STAFF USE ONLY	
Date Submitted: <u>Feb. 1, 2016</u>	Application No. <u>CD16-03CU</u>
Project Name: <u>7-Eleven conditional use</u>	
Folio No(s):

DRC COMMENT PACKAGE

**ENGINEERING & COMMUNITY DEVELOPMENT DEPARTMENT
SITE DEVELOPMENT PLAN REVIEW**

CASE #: CD16-03CU	DRC MEETING DATE: COMMENT DATE: March 3rd, 2016
Project Name: 7-Eleven	
Address: 3100 NW 9 th Avenue, Oakland Park	
Subject: DRC Engineering Review	
<u>New Development General Comments</u> <ol style="list-style-type: none">1. Add note to the cover sheet: "The proposed work has been designed in accordance with all applicable Federal, State, County and City Codes and regulations having jurisdiction. If any discrepancies exist between the plans/specifications prepared by the designer and the City Code and/or the City standard details, the later shall govern or the most stringent."2. Add note to cover sheet: All vegetation, muck, and any deleterious material within the ROW limits of all streets and alleys and required off-street parking areas must be removed and replaced with clean fill material, free of stumps, large roots or other matter not suitable for inclusion in roadway fill.3. Add note to plans: Ownership and mainten

SITE PLAN
7-ELEVEN

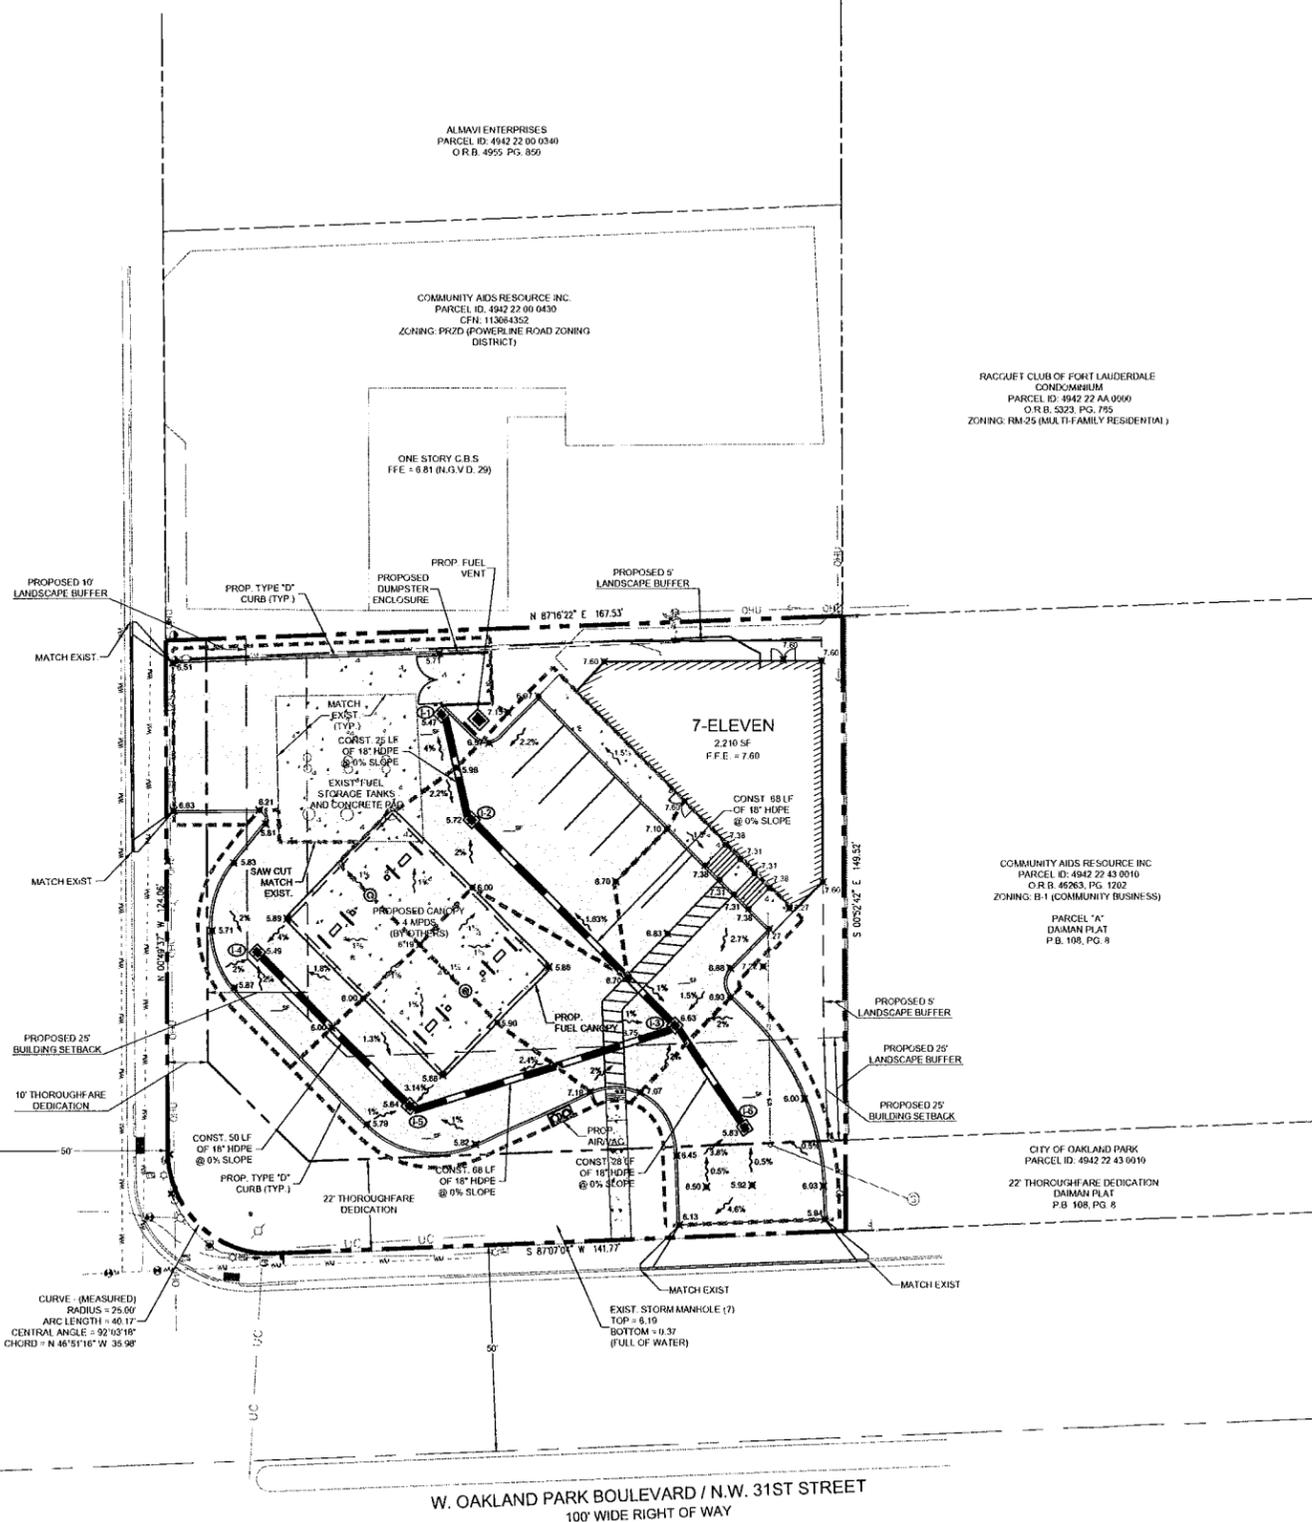
2. Provide a copy of the existing plat and/or the proposed plat showing all signature blocks, dedications of land, proposed easements etc.
3. The site plan property lines are not shown correctly. The dedication lines are the new property lines and should be shown as such in order to avoid confusion.

- 10.4. Building Footprint does not match the data table number.
 - 10.5. Provide all calculations in gross floor area.
 - 10.6. Parking Data table has incorrect data and calculations.. redo the whole table.

- 10.7. Building Height data is incorrect.
 - 10.8. Update setback table to show all distances of pumps and canopies from the areas specified in Section 24-74(C).

- 11.3. Ground floor plan
 - 11.3.1. Superimpose the floor plan on the site plan.
 - 11.4. Property lines are not correctly drawn in relation to the ROW dedication. Label the agency who will receive the off-site dedication area.

24. Parking data table is incorrect. You don't need to count parking spaces in front of a fuel island. Retail parking requirement is 1:300 sf. §24-80(C), §24-80(D)
25. Show the required 20' sight visibility triangles on the site plan and remove any obstructions from these areas. §24-83(B)(5), §24-105(C)(2)(h), §24-106(A)(2)(b)
26. Indicate that all directional and traffic control pavement markings will be thermoplastic. §24-83(A)(5)(c) & §24-83(B)(8)(c)
27. Your Paving plan shows both Type D and F curbing, but it is not clearly delineated on the plan. Type D is required on-site. §24-80(B)(2)(k)

I CERTIFY THAT THIS "ALTA/ACSM LAND TITLE SURVEY" MEETS THE MINIMUM TECHNICAL STANDARDS SET FORTH IN RULE 5J-17 OF THE FLORIDA ADMINISTRATIVE CODE.

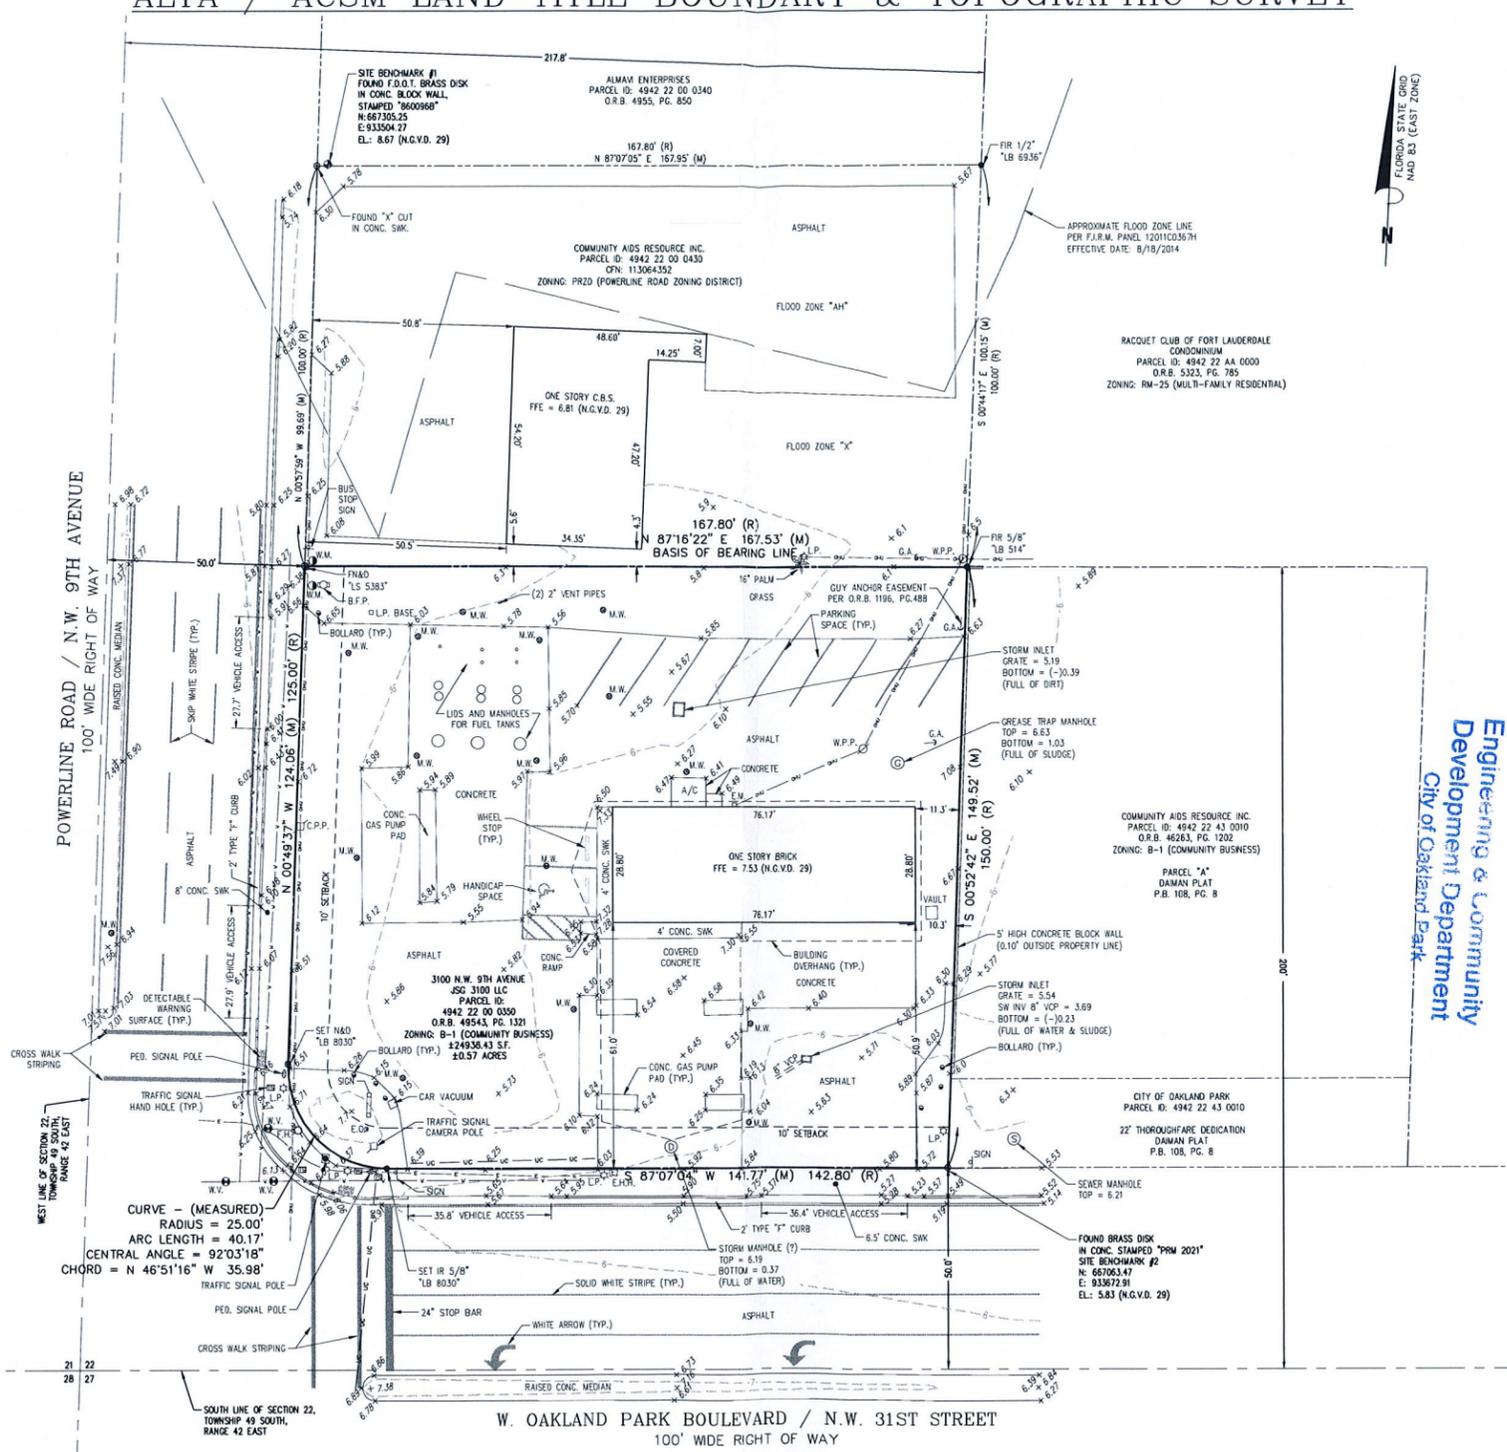
- 9.1. The survey does not show the correct property lines as this property will be platted and land will be dedicated to FDOT and/or Broward County for right-of-way.

8 DUMPSTER ELEVATIONS
3/16" = 1'-0"

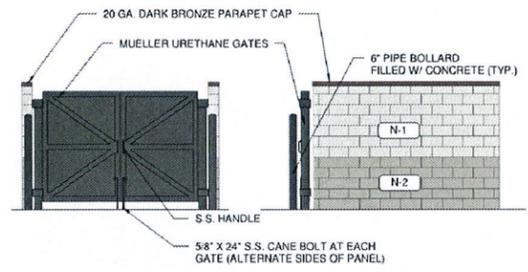
20. Provide details of the solid waste enclosure dimensions; provide detailed drawing demonstrating compliance. §13-23 & §24-165(C)(4)(e)

2 FRONT ELEVATION
3/16" = 1'-0"

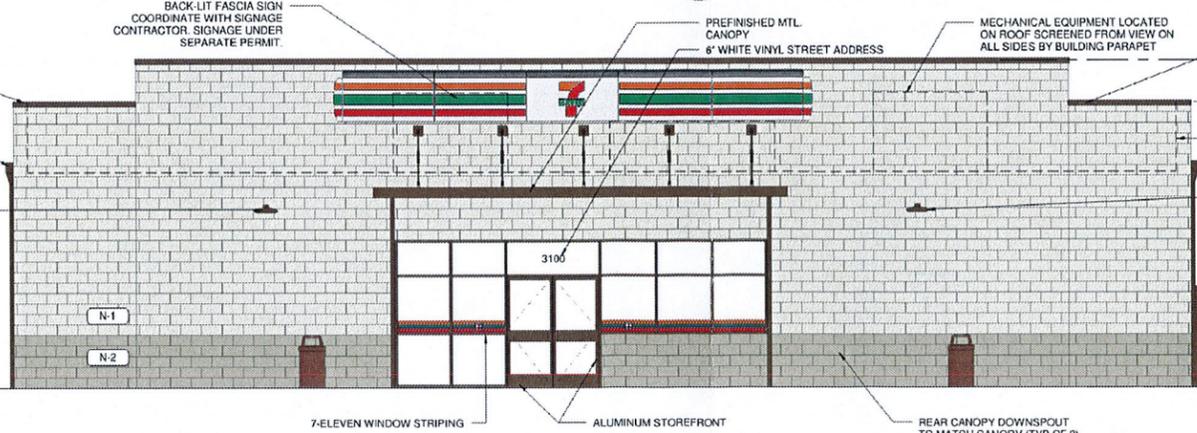
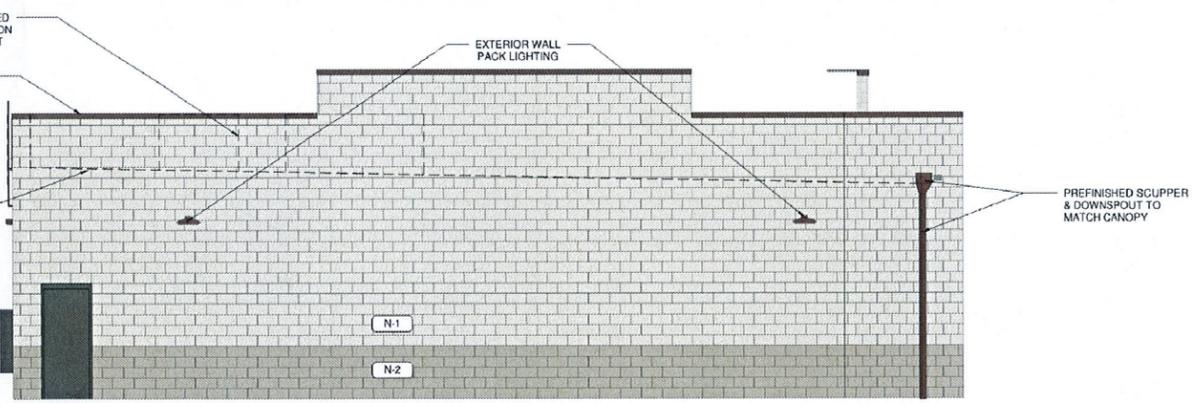
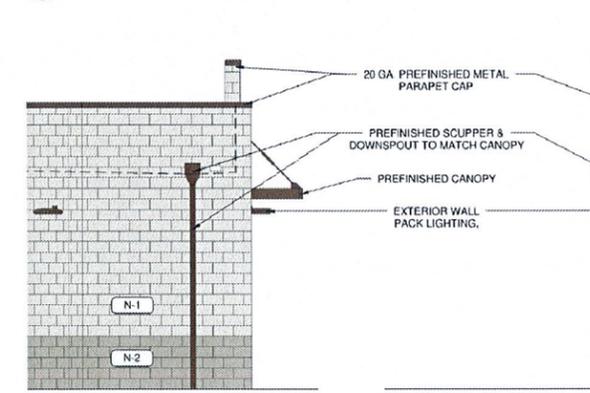
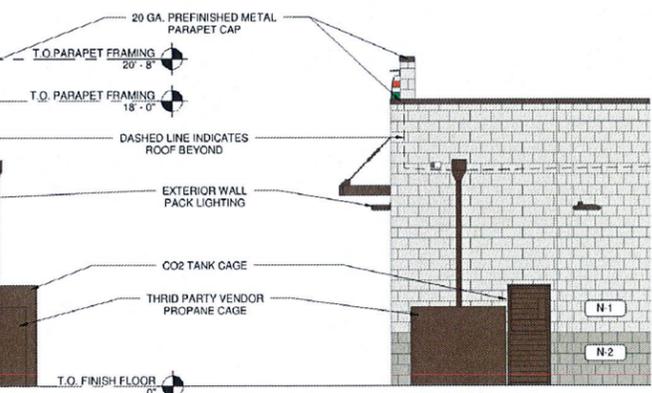
- 12.1. Provide complete details of the proposed signage on the building and on the ground.
 - 12.2. All building facades with directional labels, (north, south, east, west).

- 12.3. Dimensions, including the width of the structures.
13. Provide a photometric plan that complies with the “Minimum Site Development Plan Requirements” as stated on the Master Development Permit Application; the following items are deficient:

21. Proposed architecture lacks enough windows, uses CBS block wall with barely any other styling, is not acceptable and not consistent with adjacent quality commercial developments. To begin with, the wall should be changed to a stucco finish. CBS block wall with no finishing is unsightly. Improve the parapet instead of a metal cap. For a retail store to have this little window space is surprising.
22. Provide address numerals at least 10" high. In addition address numerals at least 3" high by rear doors. Put note on the plans or show numeral area on the building elevations. §24-145(A)(3)(b). Numerals larger than the minimum will count as wall signs.
23. Storefront canopy dimensions are not shown and appear to be too narrow for proper shelter near the doorway. Consider making the canopy deeper to properly shelter the doorway.

1 FLOOR PLAN
R0.02 1/4" = 1'-0"

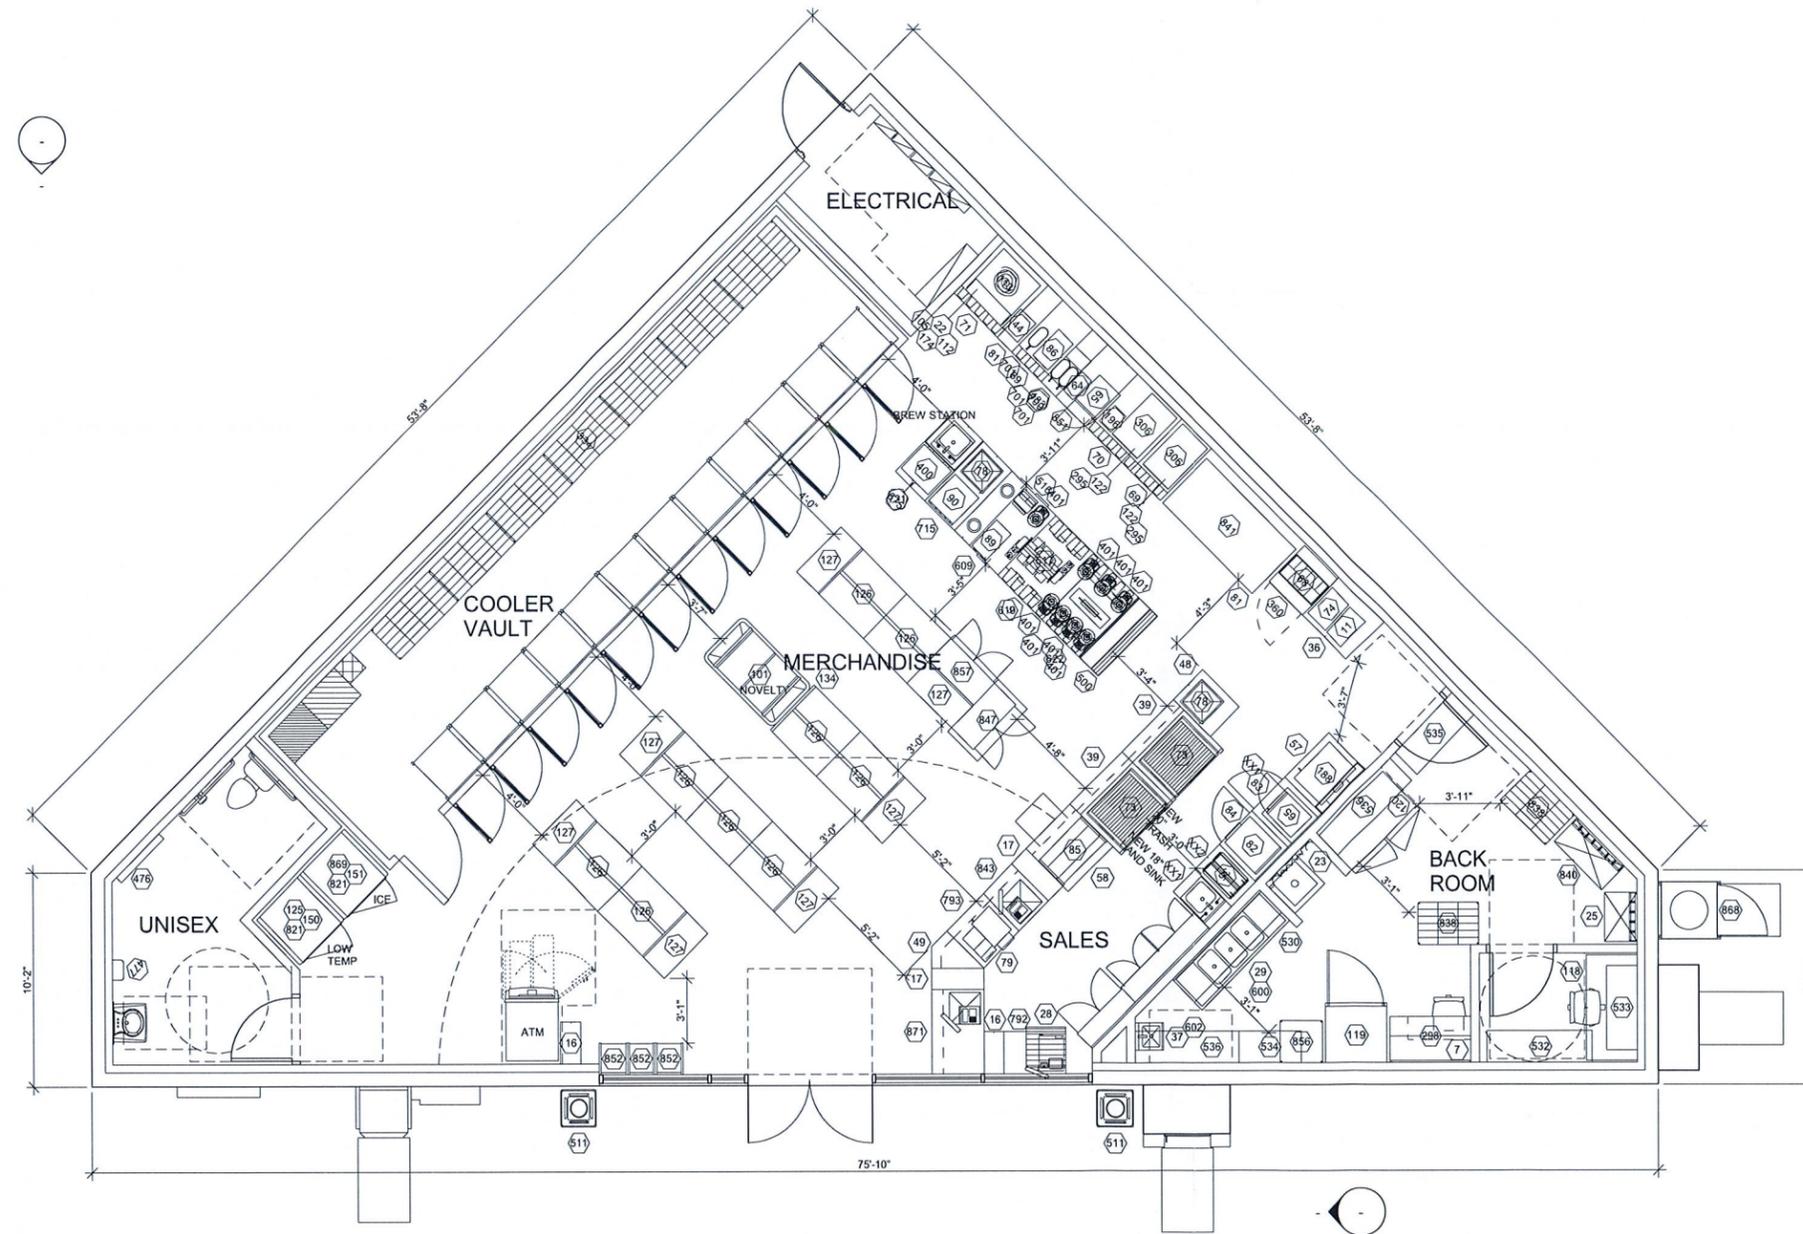
- 14.1. Delineate and dimension use of interior spaces.
 - 14.2. The floor plan is very hard to read and is not labeled to the corresponding number. There are features that are shown outside of the building in setbacks, they are not labeled, or dimensioned.
